Service Bulletin

Bulletin No.: PI0856A

Subject: Flutter or Rattle Noise Heard from HVAC Vent

Models: 2012-2013 Chevrolet Impala
Vehicles Built After February 15, 2012

2968367

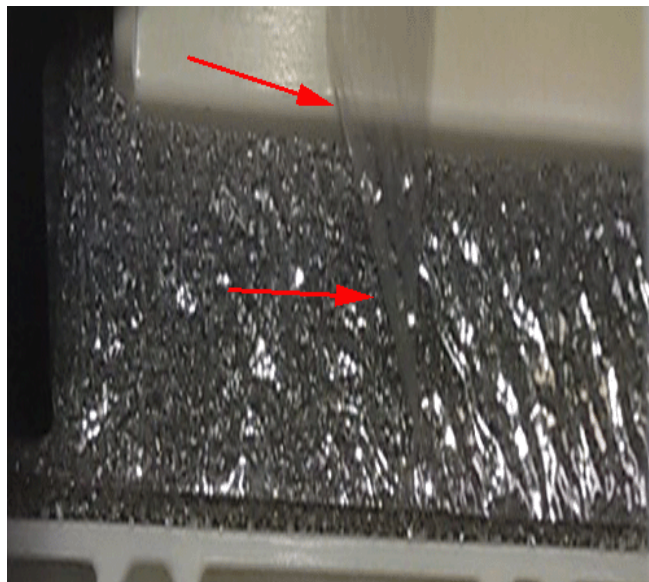
Some customers may comment on a flutter or rattle noise heard from the HVAC when using the heat or A/C. This condition may be caused by loose mylar on the foam seal under the HVAC vent doors.

Note: Mylar strip peeling off the foam as shown in the illustration above.

Follow the procedure below for removing the mylar strip off the foam seal under the HVAC vent doors:

1. Remove the instrument panel carrier. Refer to Instrument Panel Carrier Replacement in SI.
2. Remove both recirculation and mode door actuators. The technician will be able to manually open the doors to get access to the foam.

2968370

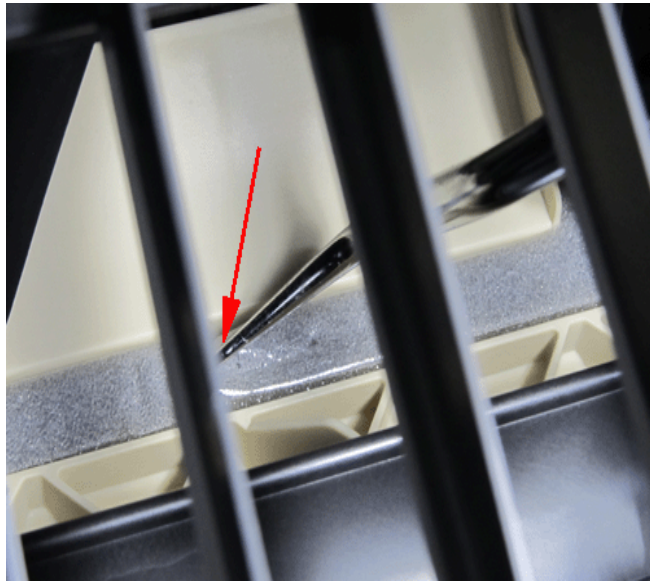
Note: Mylar strip removed from the foam as shown in the illustration above.

3. Using a hook pick type tool, remove the piece of mylar off the foam through the vents under the HVAC vent doors.
